**TECHNICAL BULLETIN**  
**Bell Helicopter** **TEXTRON**

No. 214-02-92

**MODEL AFFECTED:** 214B/B-1

**SUBJECT:** INTRODUCTION OF P/N 214-001-133-103  
COLLAR AND MODIFICATION OF EXISTING P/N  
214-001-133-001 COLLAR

FIGURE 1

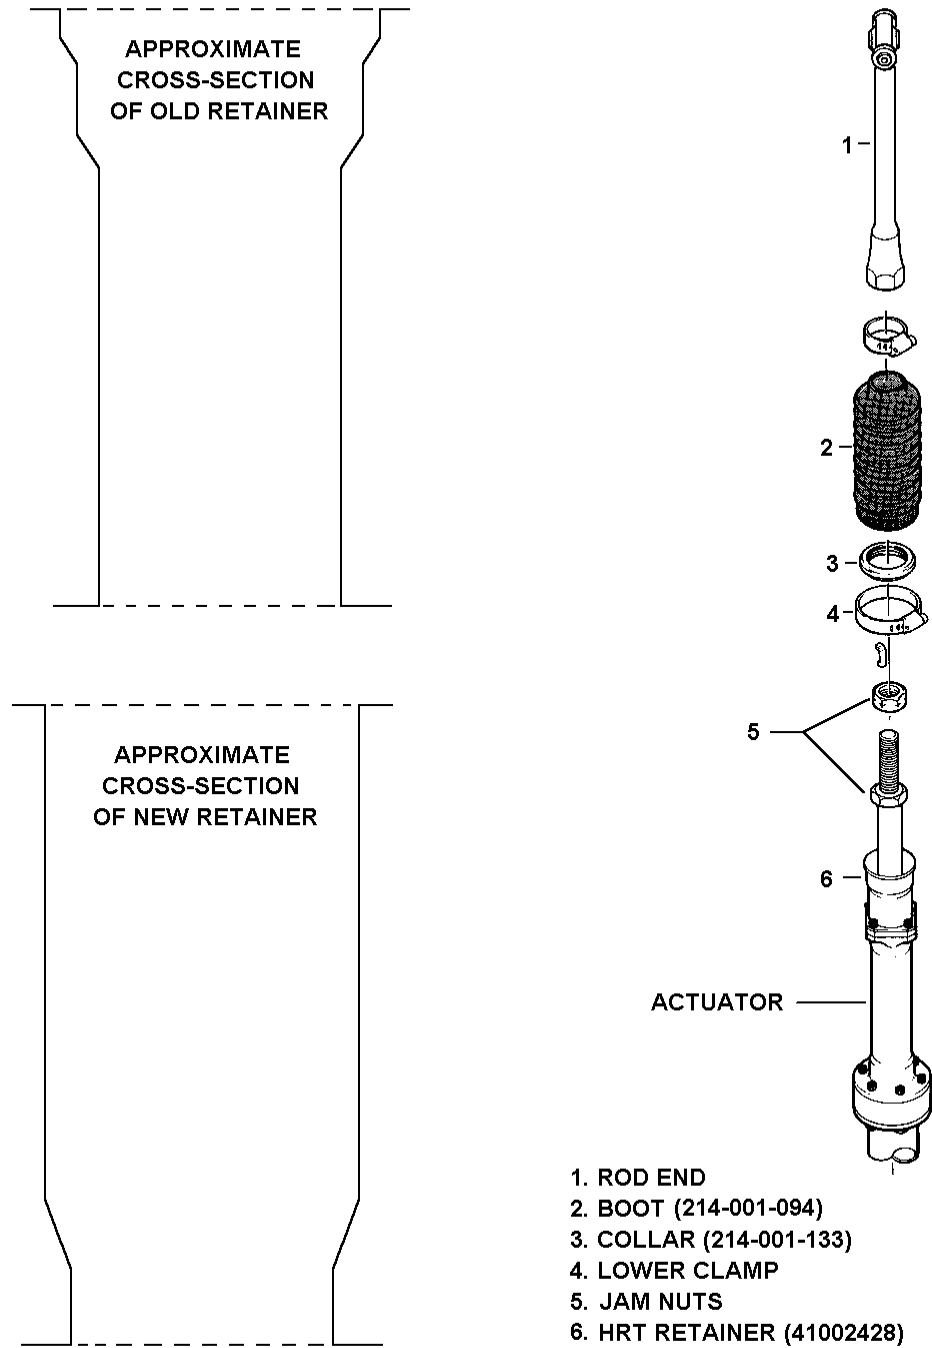
1. Refer to Figure 1 to determine differences between the old P/N 41002428 retainer and the new P/N 41002428 retainer. The P/N 214-001-133-103 Collar supersedes and replaces the -001 Collar.
2. Existing P/N 214-001-133-001 Collars may be field modified into the -103 configuration to fit new retainers as follows (see Figure 2):
  - a. Maintain the split line gap of 0.060 to 0.065 inches during the following steps.
  - b. Using a suitable method, lightly scribe, or mark, the new diameter on both outer surfaces of the collar flanges.
  - c. Using a suitable tool increase the inner diameter of both flanges evenly to the new diameter dimension. Deburr edges.

3. Refer to Figure 1. When installing the P/N 214-001-094 Boot (Item 2) over the P/N 214-001-133 Collar (Item 3) and securing with the clamp (Item 4), the collar must be free to rotate after the clamp is tightened.

FIGURE 2

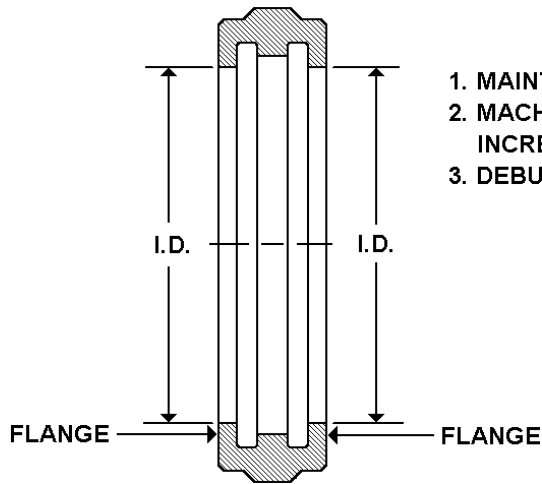
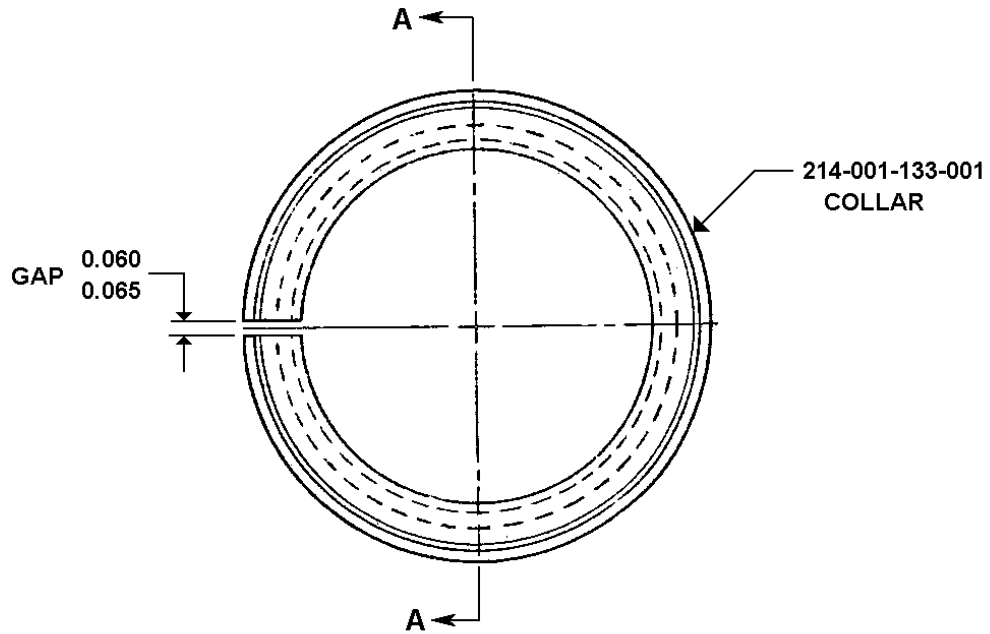
1. MAINTAIN 0.060 TO 0.065 INCH GAP ON COLLAR.
2. MACHINE I.D. OF BOTH FLANGES EVENLY TO INCREASE DIAMETER TO 2.060 +/- 0.010 INCH.
3. DEBURR FLANGE EDGES.
